UNITED STATES PATENT AND TRADEMARK OFFICE

APPLICATION NO.	FILING DATE	FIRST NAMED INVENTOR	ATTORNEY DOCKET NO.	CONFIRMATION NO.
10/534,956	04/27/2007	Paul A. Kohl	5219-091016	1856

Office Action Summary	Application No. 10/534,956	Applicant(s) KOHL ET AL.	
	Examiner YOSEF GEBREYESUS	Art Unit 2811

**FIG. 9**

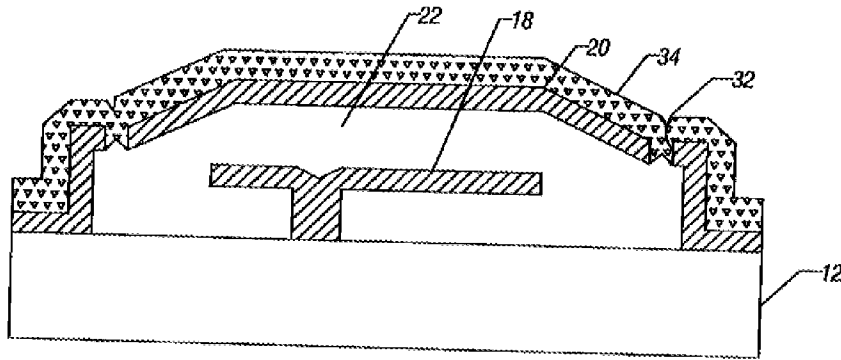
6. Regarding **claim 24**, figure 9 (figure 9 is formed with the same steps as figures 1-8 without the openings 32) (paragraph [0021]) and related text of Heck discloses forming a thermally decomposable sacrificial layer 15 and 25 (paragraph [0015]) on a substrate 12 of a micro electro-mechanical device 18, the sacrificial layer 15 & 25 encapsulating a portion of the micro electro- mechanical device 18 (paragraph [0013]) ; forming an overcoat layer (cover) 20 (paragraph [0018]) around the sacrificial layer 15 & 25; and thermally decomposing the sacrificial layer (paragraph [0015]), wherein decomposed molecules of the sacrificial layer permeate through the overcoat layer 20

(paragraph [0021]), and wherein a gas cavity 22 (paragraph [0014]) is formed where the thermally decomposable sacrificial layer 15 & 25 was formed.

7. Regarding **claim 25**, figure 9 and related text of Heck discloses depositing the sacrificial layer 15 by spin-coating (paragraph [0015]); and patterning the sacrificial layer (paragraph [0016]).

8. Regarding **claim 26**, figure 9 and related text of Heck discloses wherein the sacrificial layer 15 & 25 has a decomposition temperature less than a decomposition temperature of the substrate and a decomposition temperature of the overcoat layer 20 (the sacrificial layer 15/25 decomposes through the cover layer 20, which inherently indicates the decomposition temperature of the substrate and the cover is higher than the decomposition temperature of the sacrificial layer, paragraph [0015] & [0021]).

9. Regarding **claim 30**, figure 9 and related text of Heck discloses wherein the overcoat layer (cover) 20 has not been perforated (sealed by sealing material 34) (paragraph [0021]).

11. Regarding **claim 32**, figure 9 and related text of Heck discloses wherein the overcoat layer 20 provides an airtight (vacuum cavity) enclosure around the gas cavity 22 (paragraph [0014]).

18. Regarding **claim 52**, figure 9 and related text of Heck discloses wherein said gas cavity 22 is formed while decomposed molecules produced by decomposition of the sacrificial layer permeate the first overcoat layer 20 (paragraph [0014] and [0021]).

42. However, the examiner respectfully disagrees. First, figure 9 and related text (paragraph [0021]) of Heck teaches a continuous overcoat layer 20 (without the openings 32). Second, the definition of the word "porous" according to dictionary.com (porous 1. full of pores. 2. permeable by water, air, etc.).
